Maule Hircraft Opporation
SPENCE AIR BASE: MOULTRIE, GEORGIA 31/68 -:- PHONE 912/985-2045

## SERVICE BULLETIN #1

Subject: Horizontal tail to fuselage front attach tubes.

Models Affected: All M-4 and M-5 Series Aircraft.
M-4 Series: S/N 4 to 94, 1001 to 1045, 1S to 3S,
1T to 3T, 1C to 11C; M-4-210C, S/N 1001C to 1117C;
M-4-220S, S/N 2001S; M-4-220C, S/N 2001C to 2190C;
M-4-180C, 3001C to 3006C.
M-5 Series: M-5-220C, S/N 5001C to 5057C; M-5-210C,
S/N 6001C to 6206C; M-5-235C, S/N 7001C to 7283C;
M-5-180C, S/N 8001C to 8004C; M-5-210TC, S/N 9001C.

DETAIL A (INSPECT LEFT AND RIGHT SIDES OF THE FUSELAGE)

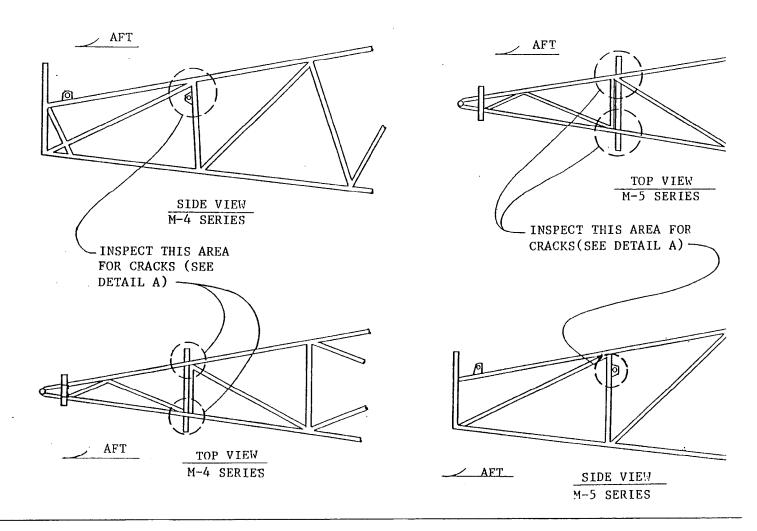
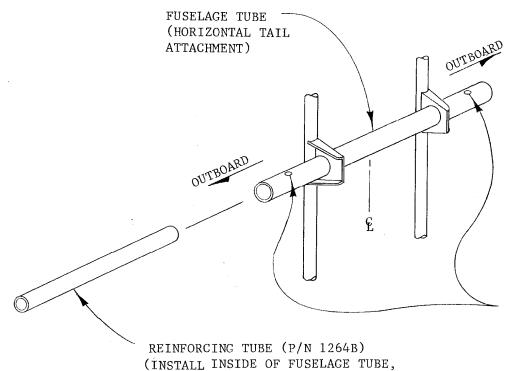
Inspect for cracks on the horizontal fuselage tube and bracket that attaches to the front attachment of the horizontal tail at the bracket weld joint. (See attached sketches), both left and right side of the fuselage.

- a. From the outside of the airplane, cut the fabric in area of the tube for clear observation of the welded area. Observation of the inboard side of the bracket in the suspected area can also be performed through the inside of the fuselage.
- b. Clean the area around the weld and inspect for cracks on both sides of the bracket visually and with at least a 10-power magnifying glass on the outboard side or dye penetrant method per FAA AC43. 13.1A, paragraph 296 or 300, on both sides of the fuselage.
- 2. If cracks are found, contact Maule Aircraft Corporation prior to further flight (Phone 912-985-2045). New parts and instructions will be sent.

USE THESE HOLES AS A GUIDE IN DRILLING HOLES IN REIN-FORCING TUBE (SEE STEP #3 IN INSTRUCTIONS).

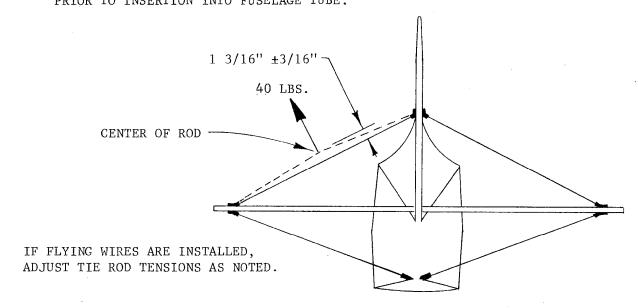
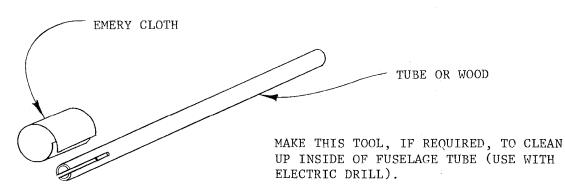
- 3. If no cracks are found, remove the horizontal tail and insert the reinforcing tube furnished with this service bulletin inside the existing fuselage tube (see sketch). This tube is to be centered inside the existing tube. Drill top holes first, then insert bolt for alignment, then drill lower holes. This new tube should remain inside the existing tube at all times. If a difficulty should arise due to weld penetration on the inside of the existing tube, remove the weld pentration by using a round file or other similar tools. Then zinc chromate tube interior prior to inserting reinforcing tube.
- 4. Re-install the horizontal tail and add fabric reinforcement in the area of the fabric cut per FAA AC43. 13-1A. On aircraft with flying wires, install flying wires in accordance with sketch on page 4 of 4.

EQUAL DISTANCE FROM BOTH ENDS).

NOTE: COAT TUBE WITH WHEEL BEARING GREASE OR EQUIV. PRIOR TO INSERTION INTO FUSELAGE TUBE.
